Fire Risk Assessment

Property assessed: B Lister Court Nightingale Avenue
London HA1 3GX

Client: Network Homes Ltd

FRA Inspection Date: 04/09/2020
FRA Issued to Client: 21/10/2020
FRA valid to: 21/10/2021
FRA completed by: Savills (UK) Ltd,
33 Margaret Street, London W1G 0JD
T: 020 7409 8737
E: fireriskhousing@savills.com

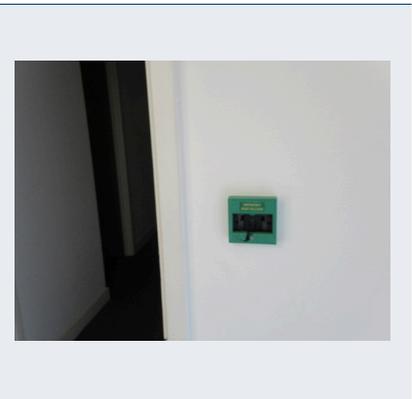
Question	K.7	<p>Comment: Green break glasses have been actuated in a number of instances and/or doors separating clusters have been forced open causing the doors/frames to become faulty/damaged and in some cases resulting in the doors not being a good fit into the frame.</p>
Section	Means of Escape	
Action ID	303965

Quantity		<p>Recommendation: Management should undertake a programme to regularly check the doors separating cluster accommodations to ensure/confirm the doors are in a satisfactory condition and the door/lock are effective.</p>
- Known	1	
- Potential	1

Question - G.3: Are escape routes kept clear of combustible items or waste materials? No

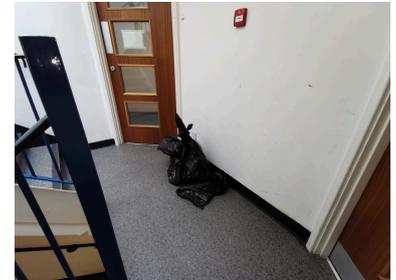
Comment: There were combustible items or waste materials in the escape routes. There were rubbish bags noted on the second-floor landing and a fabric suitcase and shopping trolley adjacent to bedroom 222. As the quantity involved is relatively minor this can be dealt with via written contact with the residents.

Recommendation: Management should contact residents to advise that the common area/escape routes should be kept free from all combustibles and/or trip hazards. A programme of regular checks should be put in place to ensure that the common area is kept clear.

Question - K.15: Are the stairs and/or lobbies provided with an automatic or remotely operated smoke ventilation system? (Detail provision and adequacy.) Yes

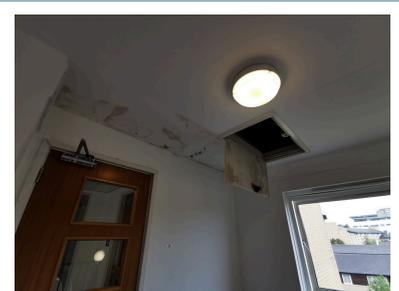
Comment: The stairs and/or lobbies are provided with an adequate automatic or remotely operated smoke ventilation system at the head of the staircase. The stairs have a smoke detector and automatic opening vents to a sky-light (main stair) or vent to a reservoir with a PV (alternative stair)

Question - N.2: From visual inspection, does the emergency lighting system appear to be in good working order? No

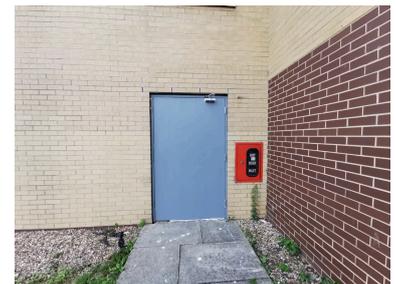
Comment: Some of the emergency lighting units did not appear to have a visible charging indicator, they are as follows: External emergency light adjacent to the front entry door. EML 18 - Cluster lobby 119-124.

Recommendation: The emergency lighting system should be checked by the maintenance engineer to confirm that it is serviceable.
